**SAN ANTONIO WATER SYSTEM
LIFT STATIONS REHABILITATION DESIGN - PHASE 3
SAWS Job No. 08-2504
Solicitation No. B-12-015-MF**

ADDENDUM NO. 4

June 6, 2012

DRAWING NO.
7 of 21

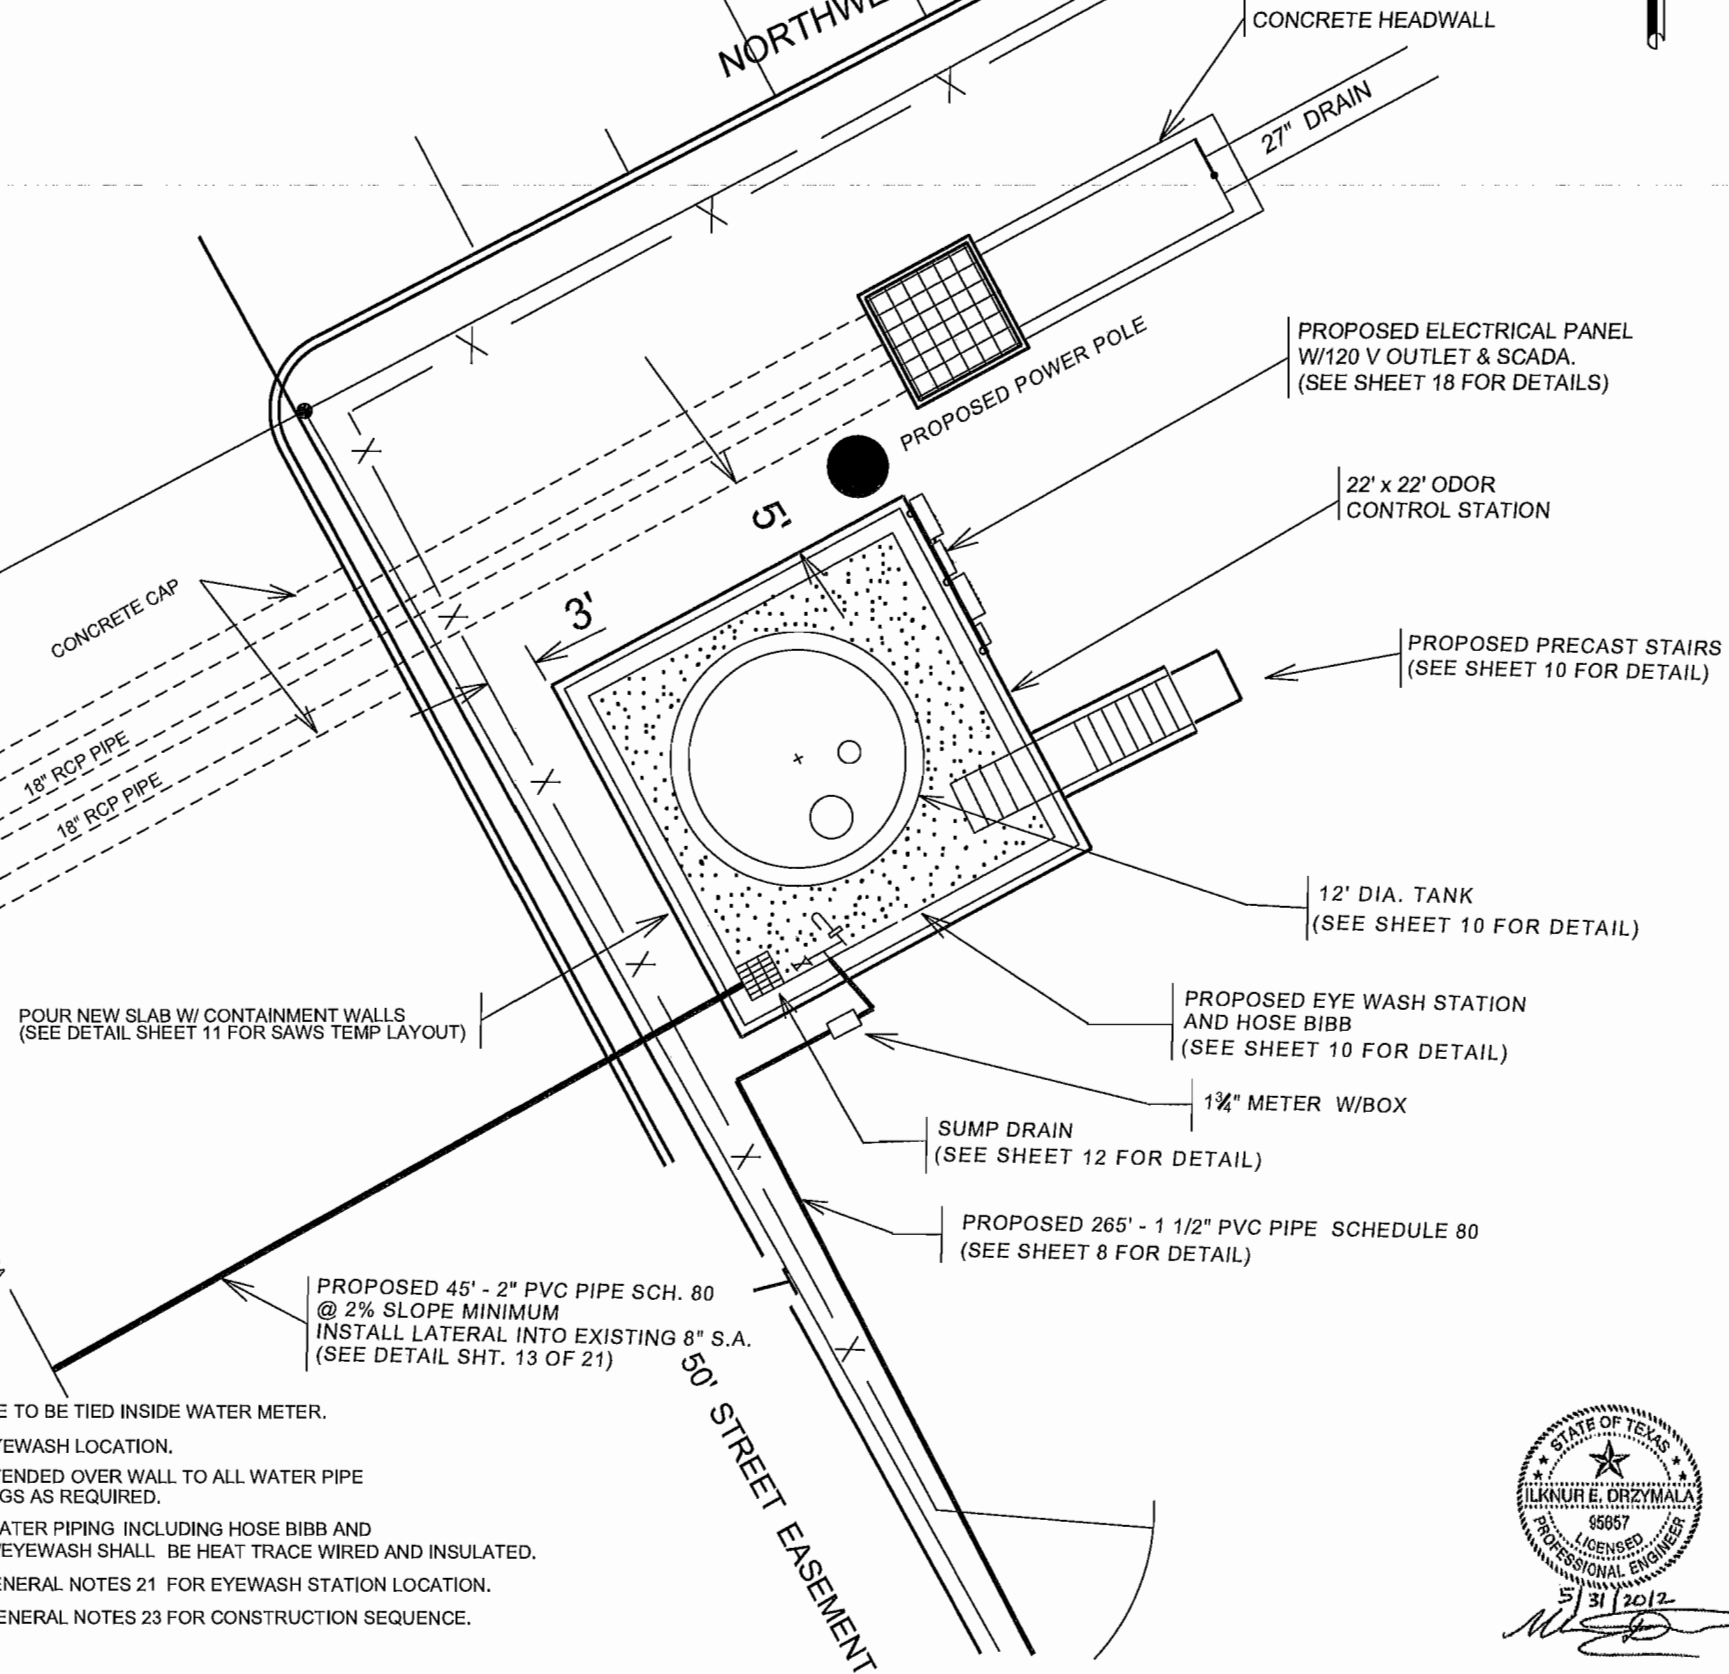
- Q3:** **Note 3 on Drawing 7 of 21 indicates the new proposed drain is 4" but the drawing calls for 2". Which pipe size is correct?**

- Q4:** **Note 6 on Drawing 7 of 21 indicates the water pipe to be tied inside water meter. What is the location of water meter?**

2-in PVC. See attached revised sheets for correct pipe size.

See attached revised sheets for water meter location.

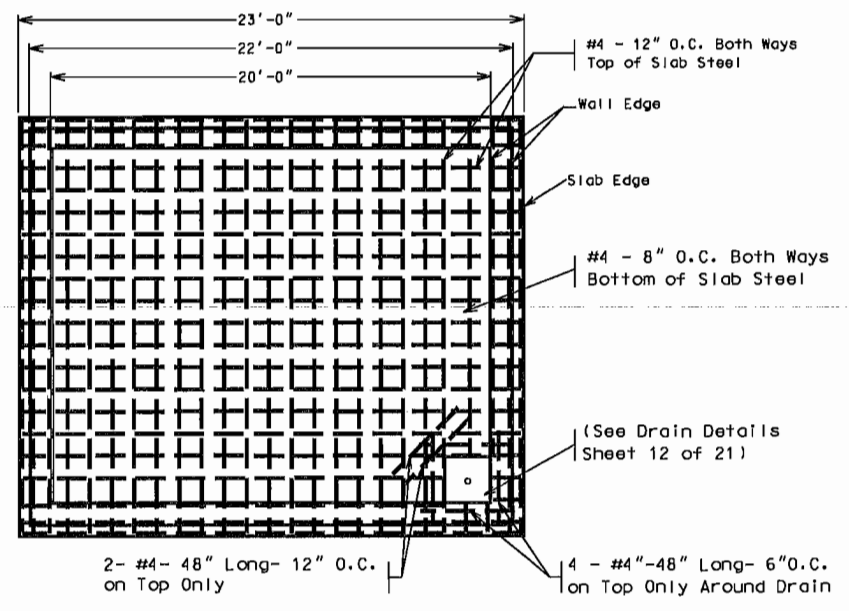
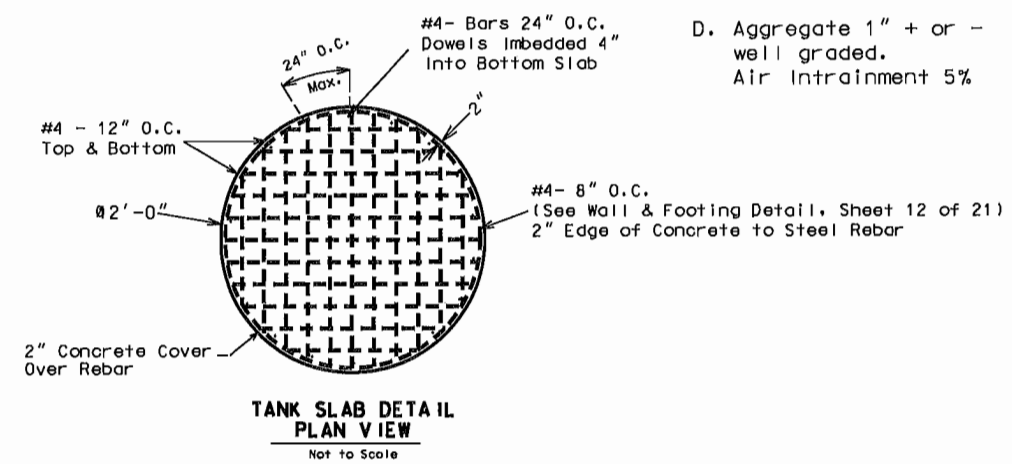
- Item 3** **Sheet 11 of 21** - Plan View: Delete the N arrow. See attached revised plan sheet.
- Item 4** **Sheet 11 of 21** - Plan View: Replace "10'-0" Tank Location" with "12'-0" Tank Location." See attached revised plan sheet.
- Item 5** **Sheet 11 of 21** - Plan View: Delete "(Installed by SAWS)" in "Poles and Electrical Panel Mounting Rack (Installed by SAWS)." See attached revised plan sheet.
- Item 6** **Sheet 11 of 21** - Plan View: The arrow indicating the 12'-0" diameter inside the circle (representing the slab) should actually extend through the dashed inner circle (representing the tank). The distance between the dashed circle (the tank) and the solid circle (the slab) should be 2'-0". See attached revised plan sheet.
